Determination 2019/002

Regarding the issue of a notice to fix for a house with foam insulation at 76 Gatehouse Lane, Woodend, Waimakariri

Summary

Figure 3: Roof insulation for east wing sloping ceilings

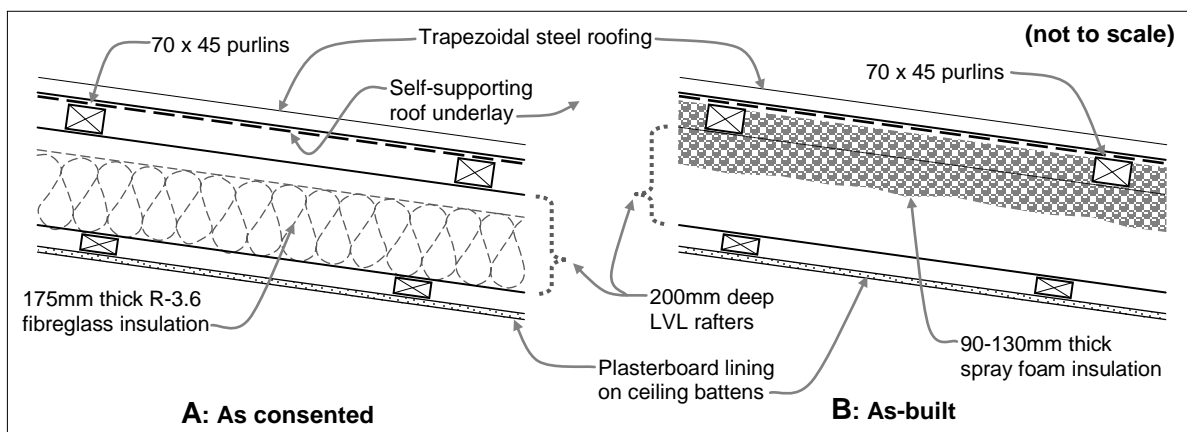
5.4.5 The expert concluded that, in conjunction with the absence of a 'detailed evaluation', the foam insulation installed to the roof (see Figure 3B) may not comply with clause E2.3.5 of the Building Code, noting:

- Installation instructions from foam insulation suppliers refer to preparation procedures for a variety of substrates, none of which include flexible roof underlays. No published information can be found that indicates a flexible underlay is a suitable substrate for sprayed insulation.
- Flexible underlays are not designed to support other materials and this risks damage to the underlay such as splits after some years when softened by absorbed water or flexing under earthquake or wind loads.

reasonable doubt ... that the sprayed foam roof insulation will comply with clause E2.3.5 of the [Building Code].

6.5.2 Taking the above circumstances into account, I do not consider there are reasonable grounds to be satisfied that the anticipated performance of the roofs as constructed will meet the requirements of Clause E2.3.5 to prevent ‘moisture being accumulated or transferred and causing condensation, fungal growth, or the degradation of building elements’.

- 7.1 With respect to the foam insulation to the roof; the applicants should address the areas described in paragraphs 6.5.1 and the discrepancies noted in paragraph 6.6.2, including a detailed proposal for remediation of roof areas, to be submitted to the authority as part of a new application for an amendment to the building consent. Any outstanding items of disagreement can be referred to the Chief Executive for a further binding determination.
- 7.2 With respect to the foam insulation to the walls; I leave this to the parties to agree on how to formalise the acceptance of this work.
